**Agenda**  
**TOWN OF BLUE RIVER**  
**PLANNING AND ZONING COMMISSION REGULAR MEETING**  
**July 5, 2022**

# Ransberger Garage

TO: Michelle Eddy, CMC/CPM - Town Manager/Clerk  
FROM: Thomas Marshall, Plan Reviewer - CAA  
DATE: June 28, 2022  
RE: Planning/Zoning/Architectural Guidelines review –  
0171 Blue Rock drive

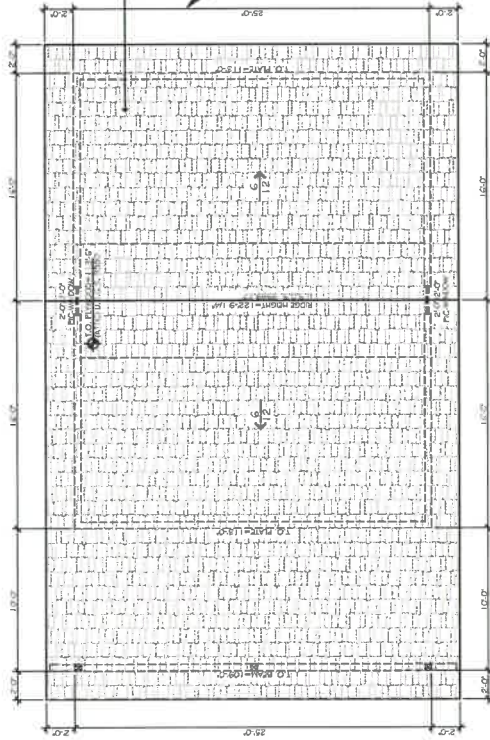
STANDARD	NOTES/REMARKS	SUBSTANTIAL COMPLIANCE
<b>DEVELOPMENT STANDARD</b>		
VI. B. Building Envelope	The proposed structure is properly sited within required setbacks. <b>An existing non-conforming shed is identified outside the building envelope.</b>	
VI. C. Building Siting	Structure is proposed in context with natural drainage patterns, contours, and landforms.	Y
VI. D. Grading and Drainage	Cut and fill slopes have been kept to a minimum and final grading is proposed to avoid unnaturally broad, flat surfaces.	Y
VI. E. Driveways	A 15' wide recycled asphalt driveway is proposed as an extension to the existing gravel driveway to serve the new garage. Snow storage areas are depicted off the driveway area and meet the minimum required area. <b>The maximum allowed driveway width is 12'. Proposed methods for storm drainage and general direction of flow away from both structures, the slope and cross slope of the driveway extension are required and will be evaluated at building plan review for compliance.</b>	N

VI. F. Parking / Garages	The proposed detached 800 S.F., 3 vehicle bay garage complies. <b>The proposed 250 S.F. carport is prohibited.</b>	N

VI. G. Exterior Equipment and Satellite Dishes	All identified equipment is existing and appears to be in general conformance. <b>The overhead electrical drop will be reviewed for clearance above the driveway at building plan review.</b>	
VI. H. Easements and Utilities	Road access easement is identified on plans	Y
VI. I. Recreation Facilities	None identified on the plans.	N/A
VI. J. Signage	None identified on the plans. Existing home.	N/A
VI. K. Pathways /Walkways	A 4' wide concrete apron is proposed on 3 sides of the garage.	Y
VI. L. Wetlands	No wetlands are identified on the plan.	N/A
VI. M. Wildfire Regulations	Many of the required regulations are operational requirements post-construction. A statement of compliance is noted on the site plan.	Y
<b>ARCHITECTURAL GUIDELINES</b>		
VII. B. Building Forms	Proposed foundation walls merge with the existing grade.	Y
VII. C. Setbacks	The identified exterior parking is set within the building envelope.	Y

## SOUTHWEST ELEVATION

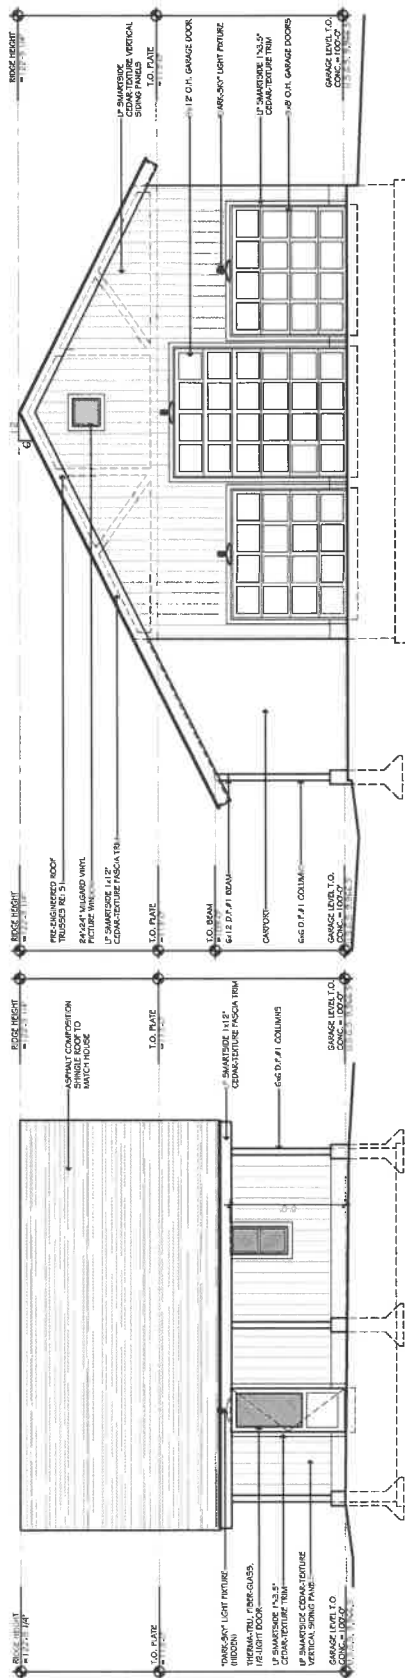
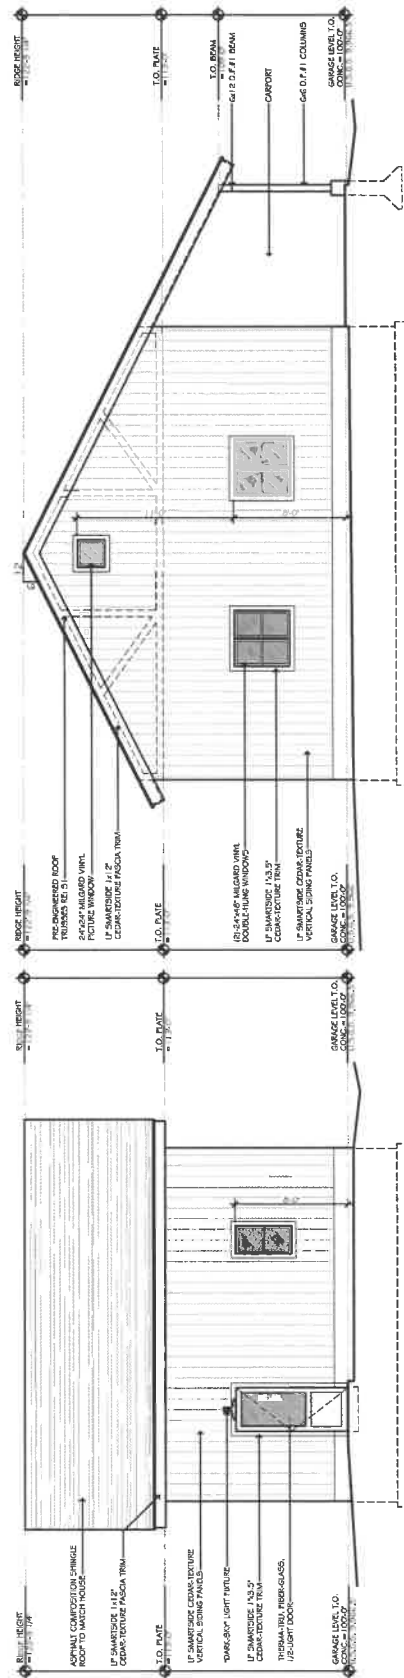
VII. D. Building Height	Building complies with zoning district requirements.	Y
VII. E. Roofs	Primary roof slopes are 6:12 which is consistent with the suggested standards of 4:12 – 12:12 for primary roofs. The proposed roof cover is a GAF composition shingle "Charcoal" to match the existing home. <b>Design consideration should be given to the SE side door location due to the potential for snow shedding upon pedestrians.</b>

Materials & Colors  
Ransberger Garage #17022  
Equinox Architecture LLC 6/8/22

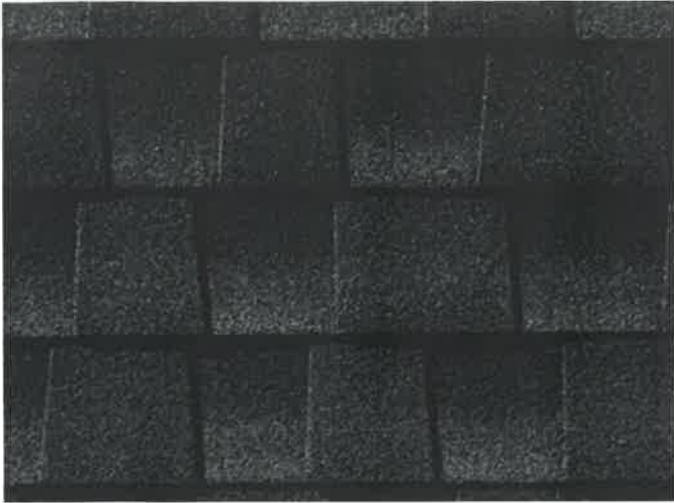
VII. F. Exterior Wall Materials	LP Smartside Cedar-Textured vertical siding panels. <b>Photographs of the principal home were not provided, and it is not noted if the proposed colors and materials will match the existing home.</b>	
VII. G. Exterior Trim	Proposed exterior composite LP Smartside Cedar-textured trim stained "Deep Sierra". <b>Photographs of the principal home were not provided, and it is not noted if the proposed colors and materials will match the existing home.</b>	
VII. H. Windows and Doors	Windows, doors, and garage doors are proportional to the structure appear in general compliance. <b>Photographs of the principal home were not provided, and it is not noted if the proposed colors and materials will match the existing home.</b>	
VII. I. Balconies and Railings	No railings, balconies or exterior stairs are proposed.	N/A
VII. J. Chimneys and Roof Vents	No chimneys proposed.	N/A

VII. K. Exterior Colors	<b>Photographs of the principal home were not provided, and it is not noted if the proposed colors and materials will match the existing home.</b>	
VII. L. Solid Waste Collection and Service Areas	Exisiting	Y
<b>SITE ELEMENTS</b>		
VIII. A. Retaining Walls, Landscape Walls, Fences, and Screening	None proposed	N/A
VIII. B. Terraces, Patios, Walkways and Decks	The 4' wide concrete apron on 3 sides of the proposed garage complies.	Y
